**Board of Adjustment
February 13, 2018
Staff Report**

A request by Timothy R. Gerding (attorney), on behalf of 1013 Park Avenue, LLC (owners), to grant variances to the required front yard setback, allowable accessory structure coverage, and accessory structure location which are not permitted per Sections 29-4.1(a), Table 4.1-3 and 29-3.3 (ii)(1), of the Unified Development Code so as to permit construction of an outdoor stage on property addressed as 1013 Park Avenue.

BOA Case # 1958

Variance - Rose Music Hall

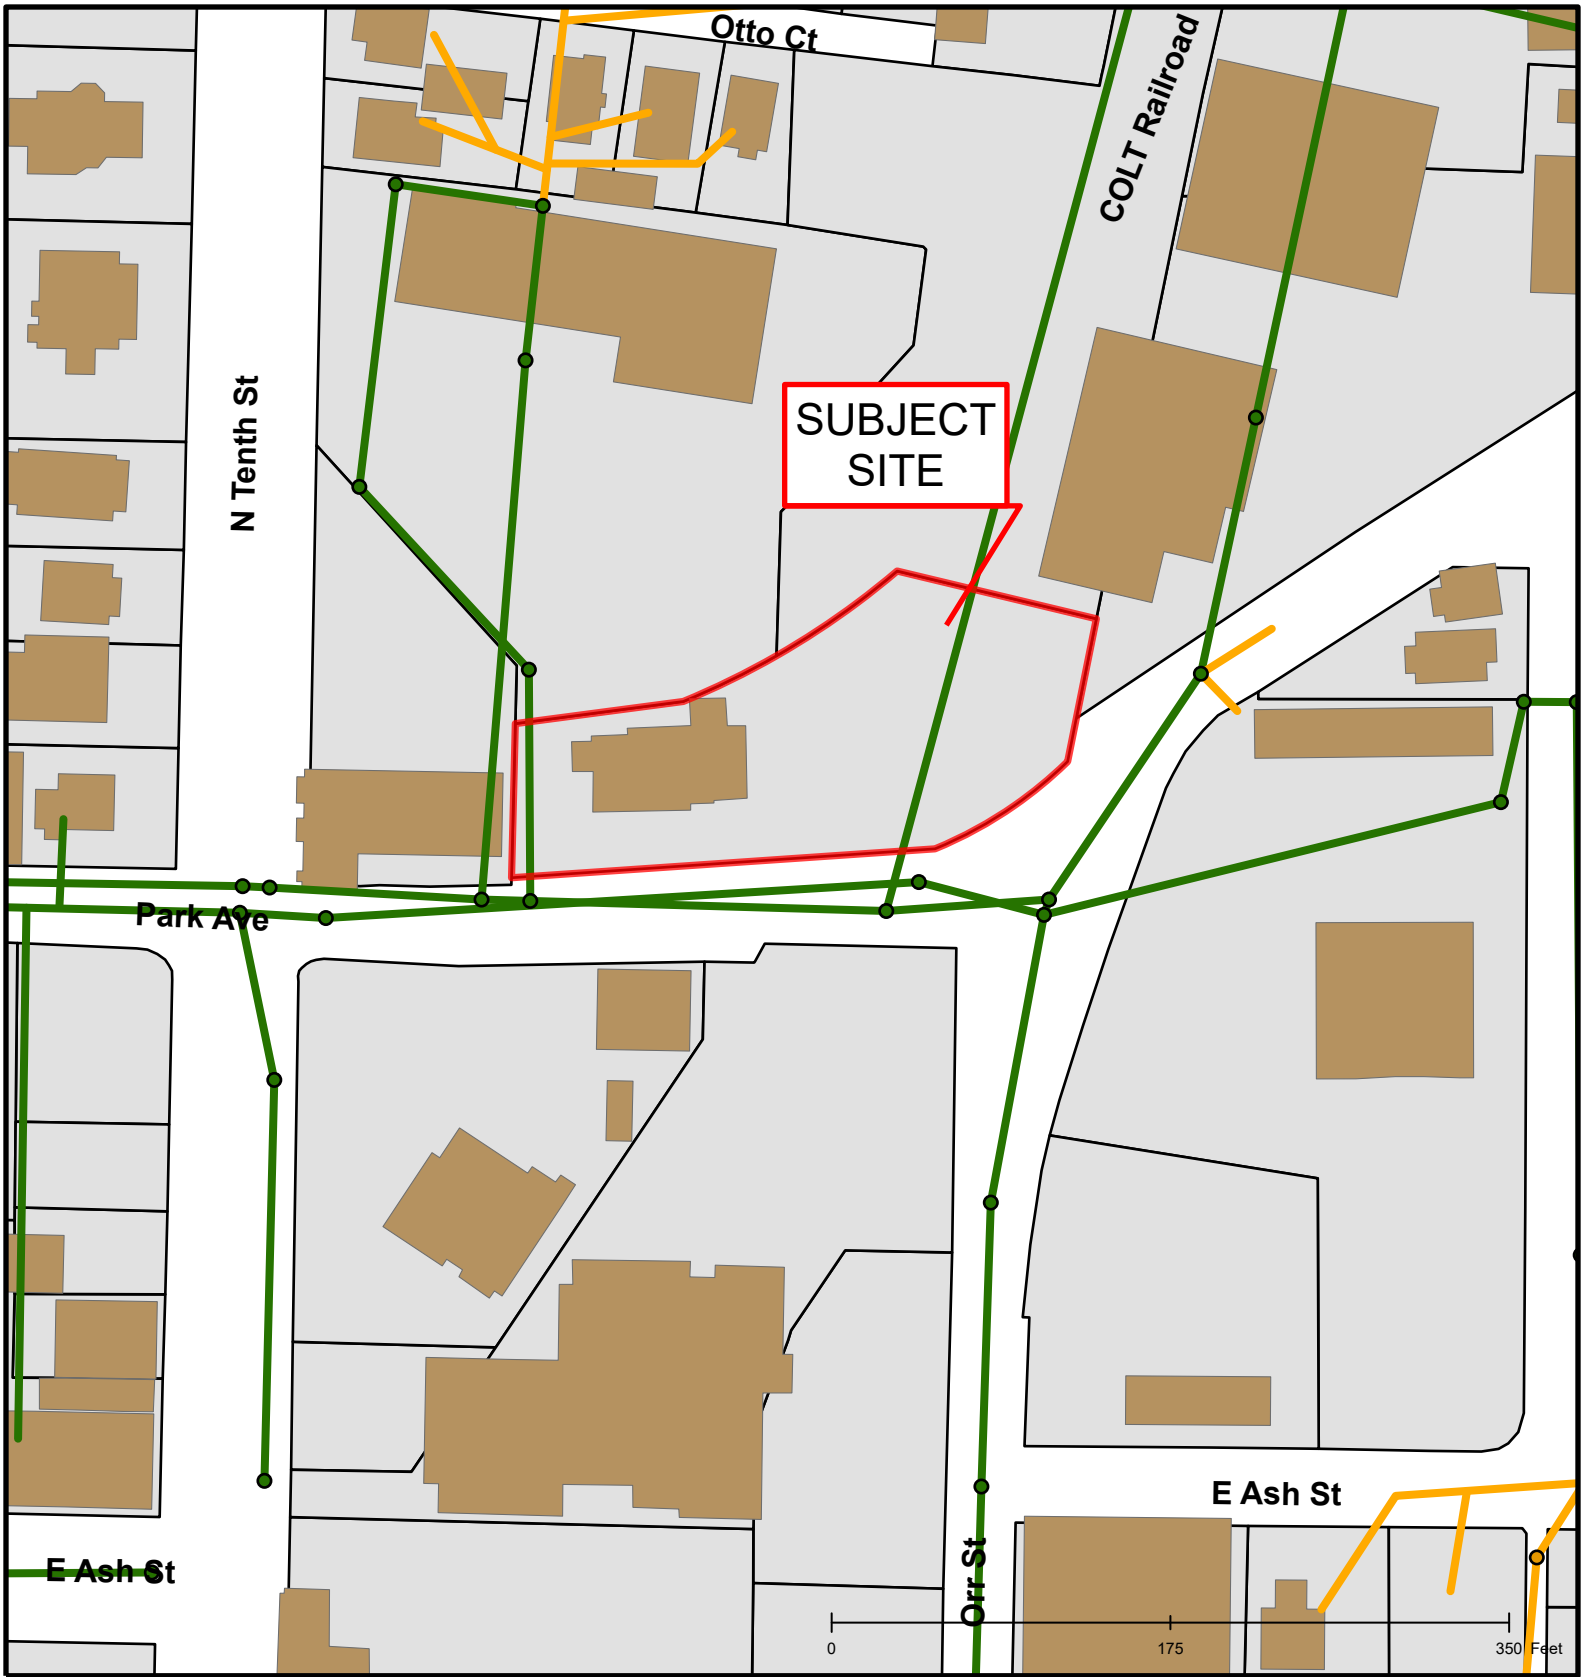
Given the site's sloping northeasterly topography, the placement of the current stage within the required setback area is the most convenient location so as to optimize the usage of the site as an outdoor concert venue. The previously unpermitted 317 square foot stage was generally in the same location (see highlighted site plan) and was approximately 10-feet into the required setback. From site evaluation there appears to be no unique site feature that justifies the need to adjust the setback as requested. It should be noted; however, that relocation of the existing stage onto a different portion of the site may be less optimal for adjacent property owners given the impacts that an outdoor concert venue can create.

3. **Section 29-3.3 (ii)(1)(iii)** - A variance to permit an accessory structure to be closer than 10-feet to another structure. If granted, the stage would be permitted to overlap the southeast corner of the existing paved patio area which is now considered a structure.

Denial of requested 25-foot variance and allowance of the stage to encroach into the required setback. A 0-foot front yard setback is inconsistent with adjoining development on similar IG zoned property and no known site characteristic limits compliance. **Alternatively if the Board finds**, given site conditions and the surrounding land use context that a reduction is appropriate, a variance of 15-feet could be approved. Such variance would result in the stage being located 10-feet forward of the required setback in a location generally consistent with the original unpermitted stage.

Denial of the variance allowing the area allocated to accessory structures to exceed that devoted to the primary structure. Reduction of the area allocated to the patio, stage, or a combination of the two would result in compliance with the existing regulations.

Modification of the paved area of the patio or relocation of the stage to another portion of the site would result in compliance with the regulations. **Alternatively if the Board finds**, that no public health, safety, or welfare is compromised by the allowing the two structures to within 10-feet approval could be approved.
